Terraffic Pty Ltd

RE DA2020/0824 – 321-331 CONDAMINE STREET, MANLY VALE

I refer to Council's letter to Manly Vale Developments No.2 Pty Ltd dated 28th June 2021 relating to concerns regarding vehicular access. The traffic related issues have been addressed as follows:

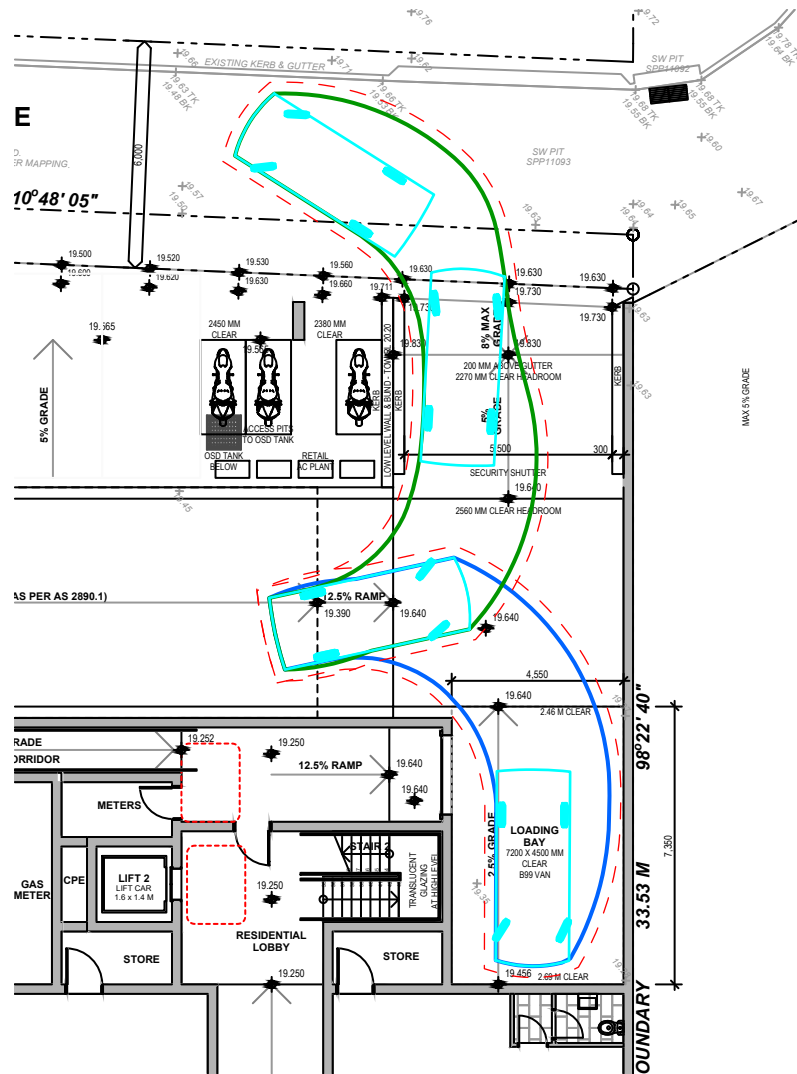
- vii. *That adequate visibility to pedestrians and vehicles will be available on Sunshine Street given the location of proposed landscaping on the south west corner of the site.*

As can be seen in the graphic below, the development plans now provide compliant pedestrian sight lines at Sunshine Street.

**Manoeuvring Path of Australian
Standard AS/NZS2890.1:2004
B99 Vehicle Accessing Loading Bay**

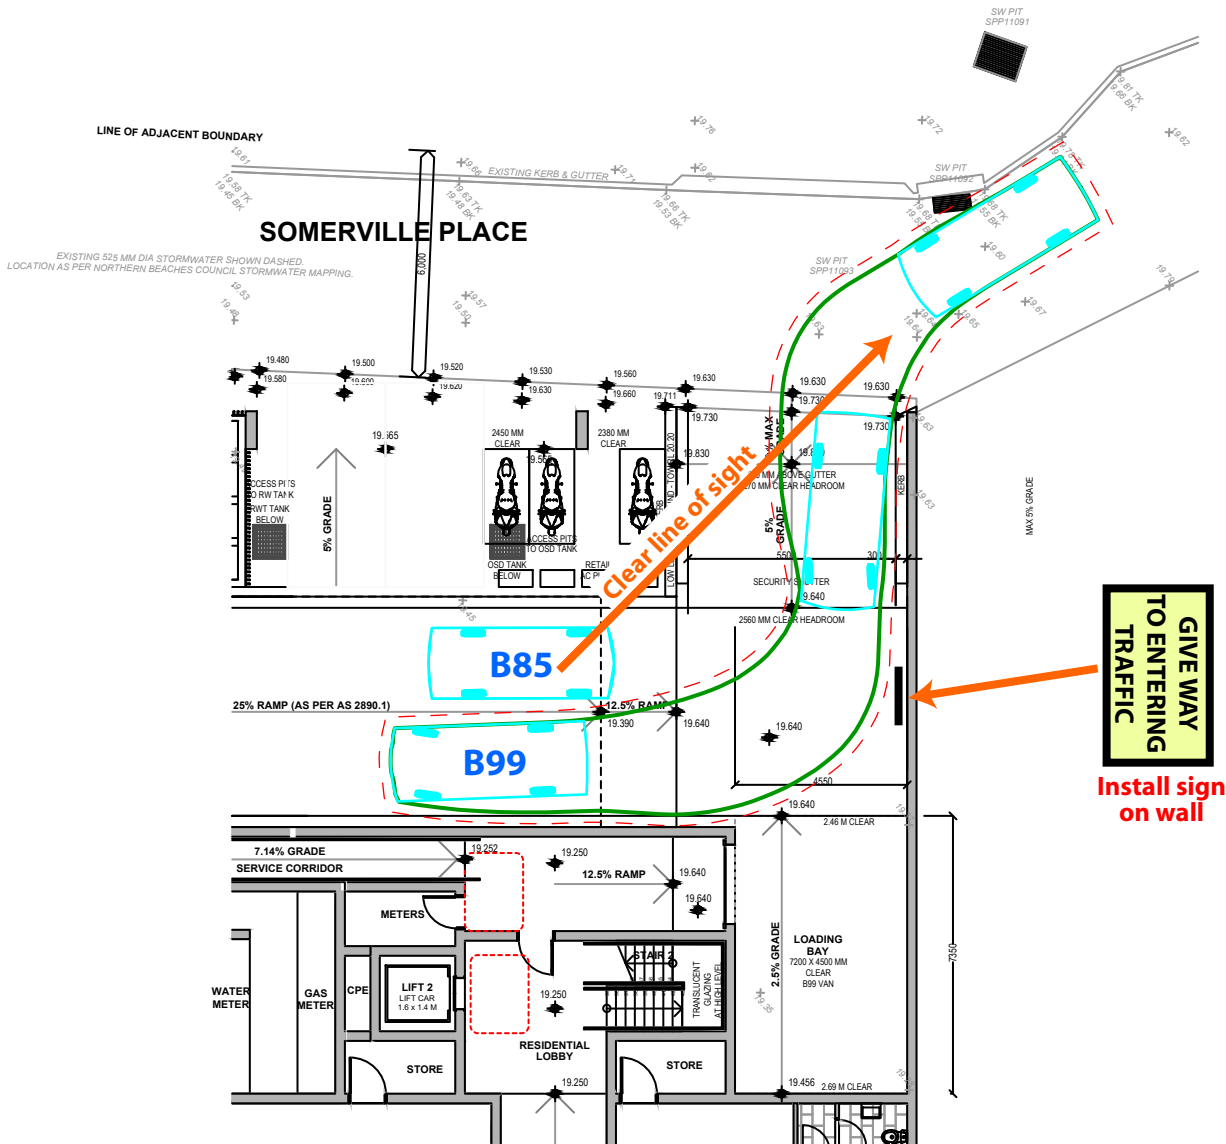
- a. *Swept path diagrams are required to demonstrate that safe manoeuvring can be achieved and to specifically to confirm:*
 - i *How the largest vehicle proposed to access the loading bay will ingress and egress to and from the loading bay in a forwards direction noting the constrained conditions on Somerville Place and its One Way traffic flow.*

The proposed development is served by a 7.3m x 4.5m loading bay on the ground level capable of accommodating a typical courier van similar in size to the B99 vehicle specified in the Australian Standard AS/NZS2890.1:2004. The B99 vehicle is similar to the Ford Transit Medium Wheelbase Van and measures 5.2m x 1.94m. This vehicle will adequately serve the 4 small retail shops.

In the circumstances where a larger vehicle is required to make a delivery, this vehicle will temporarily park in the 1 HOUR PARKING zone along the Condamine Street frontage as per the current arrangements. Keeping the larger vehicles to the higher order road network would be preferable to making them travel along a one way laneway.

The swept path of the B99 vehicle exiting the loading bay is reproduced in Annexure A. As can be appreciated, the vehicle can comfortably enter the loading bay in one manoeuvre.

**Manoeuvring Path of Australian
Standard AS/NZS2890.1:2004
B99 Vehicle Entering Basement and
Passing a Waiting B85 Vehicle**

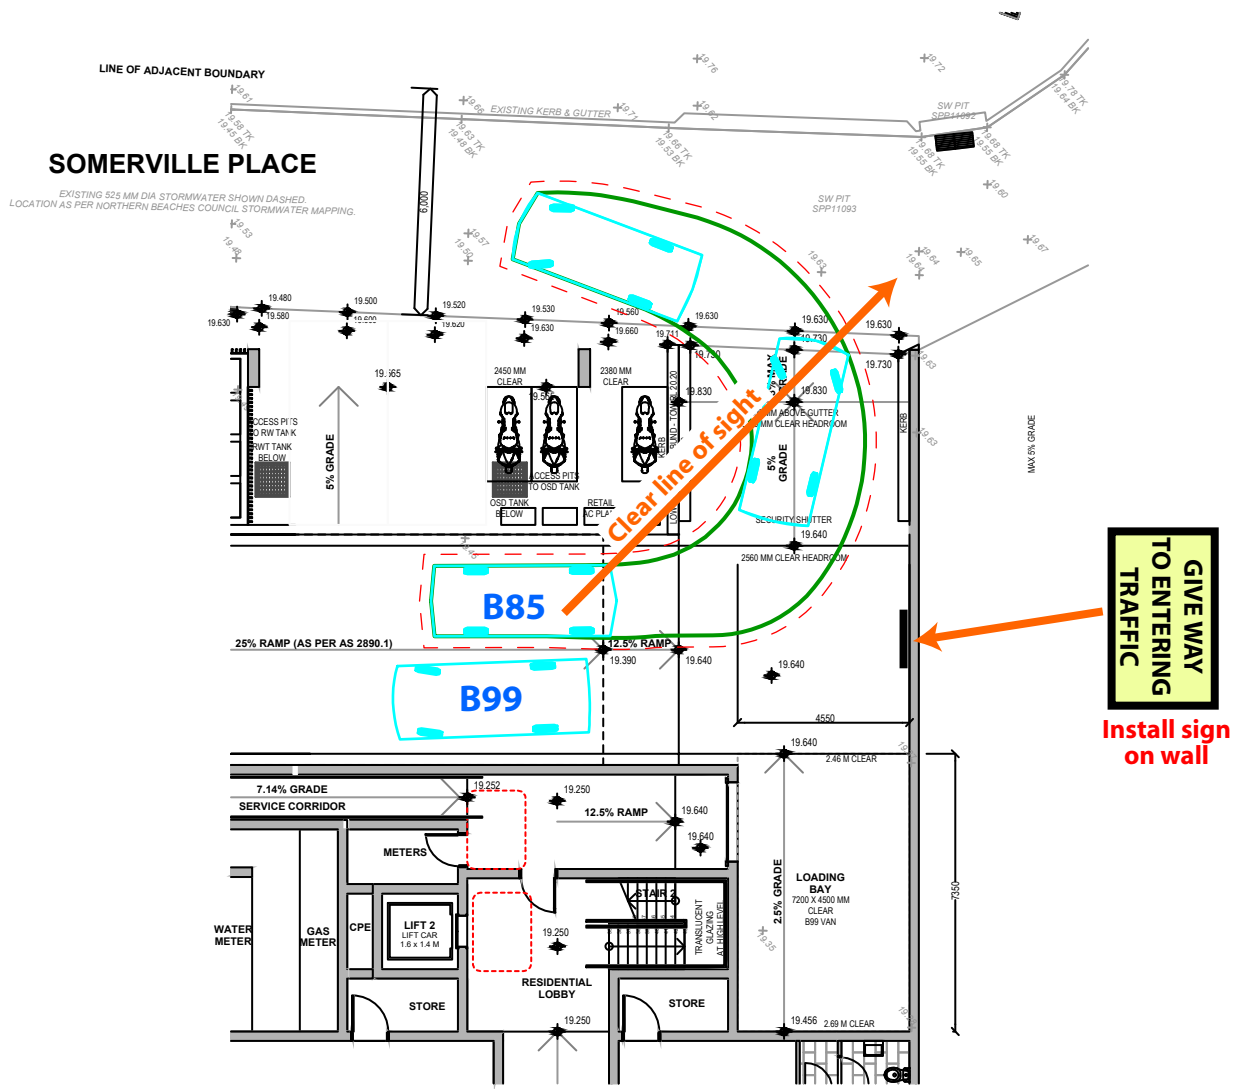
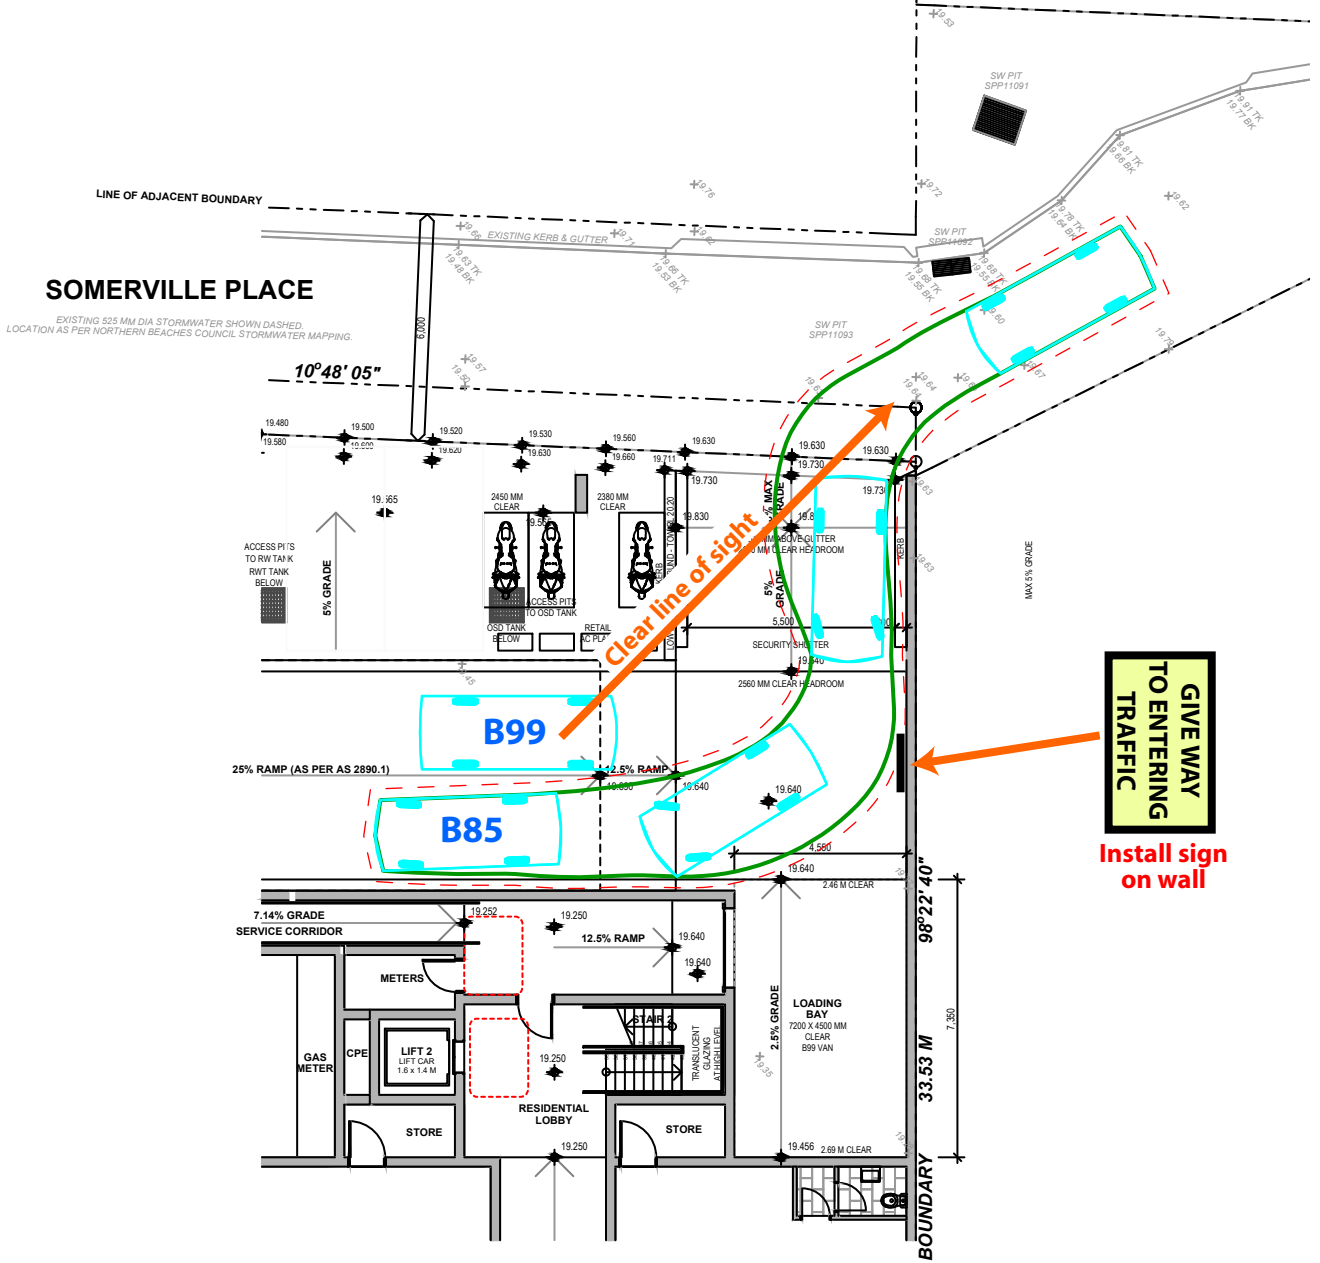
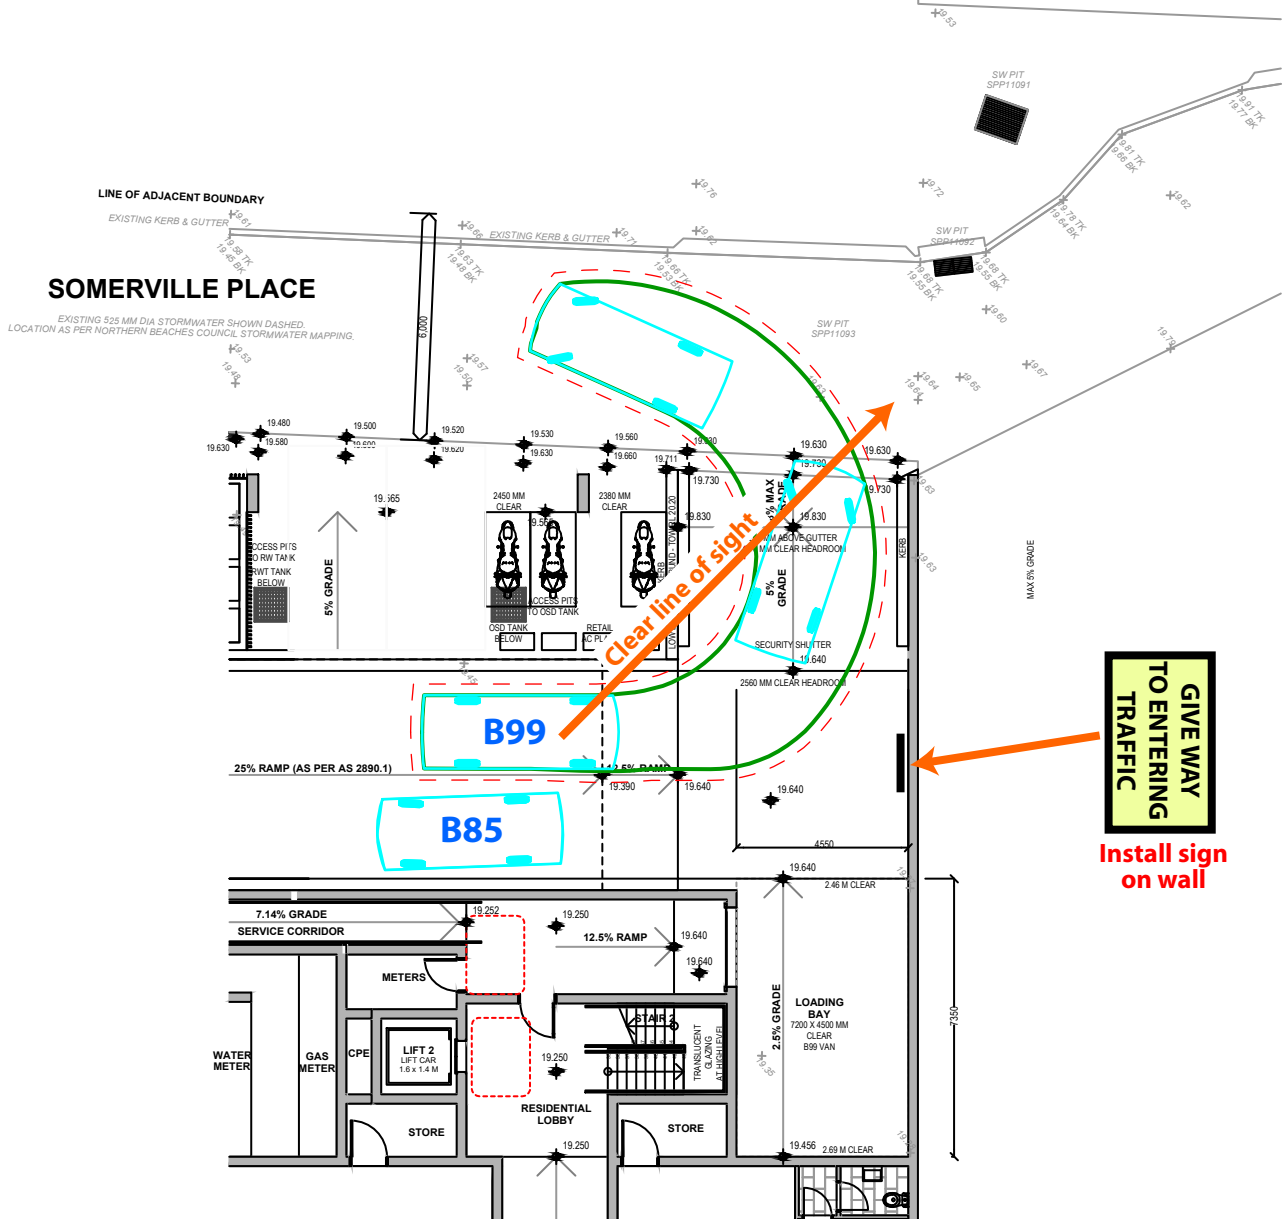
- ii. *How concurrent entry to the driveway by a B99 vehicle and egress from the carpark levels by a B85 vehicle can occur.*
- iii. *How concurrent entry to the driveway by a B85 vehicle and egress by a B99 vehicle from the carpark levels can occur.*

Due to the relatively low traffic flows along Somerville Place and those generated by the proposal, the access arrangements off Somerville Place were not designed to provide concurrent “free flows” where entering and exiting cars can pass at the same time. The intent of the design was to provide a clear line of sight for drivers to see approaching traffic and give way accordingly.

The swept paths of the B99 and B85 vehicles accessing the site are reproduced in Annexure B. As can be seen, drivers coming up the ramp will be able to see if a vehicle is turning into the driveway. As can be appreciated, a driver entering the site can also see a car exiting and will stop temporarily in Somerville Place to allow the car to depart.

**Manoeuvring Path of Australian
Standard AS/NZS2890.1:2004
B85 Vehicle Accessing Retail
Parking Spaces 1 and 2**

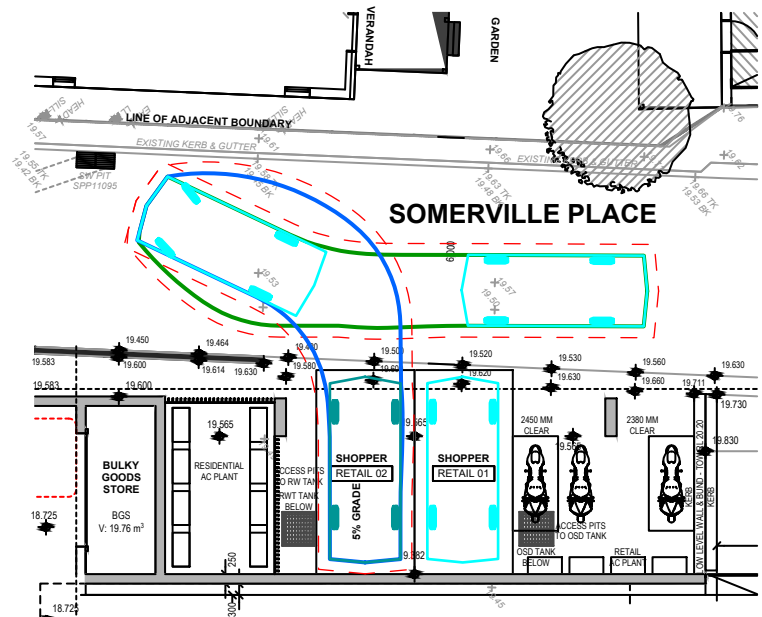
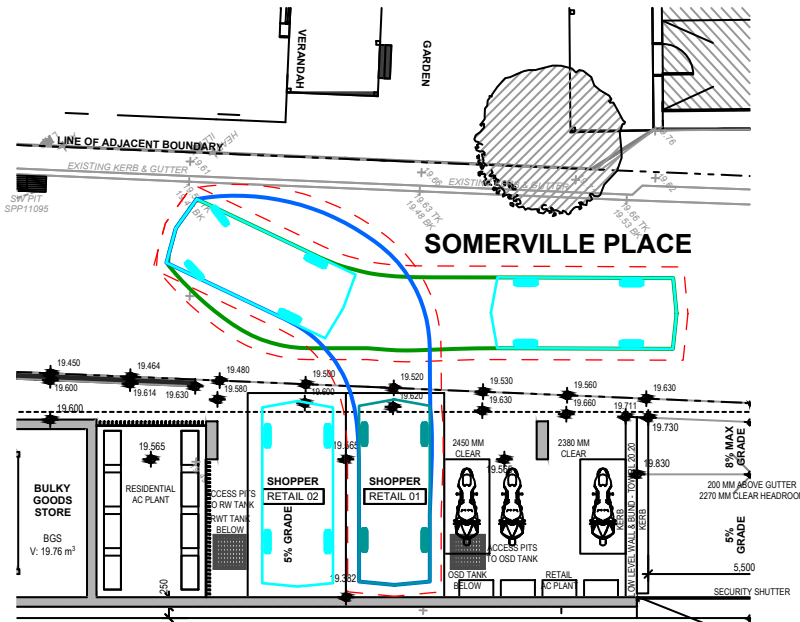
- v. *How vehicles will be able to enter and egress parking spaces Retail 01 and Retail 02 without impacting upon fences or bollards on the western side of Somerville Place.*

The swept path of the B85 vehicle accessing each Retail space off Somerville Place is reproduced in Annexure C. As can be seen, the vehicle makes a total of 3 manoeuvres (2 entry + 1 exit turn). The assessment has been carried out using the Autodesk Vehicle Tracking software which was created for the simulation of vehicle turning manoeuvres and ground clearance evaluation.
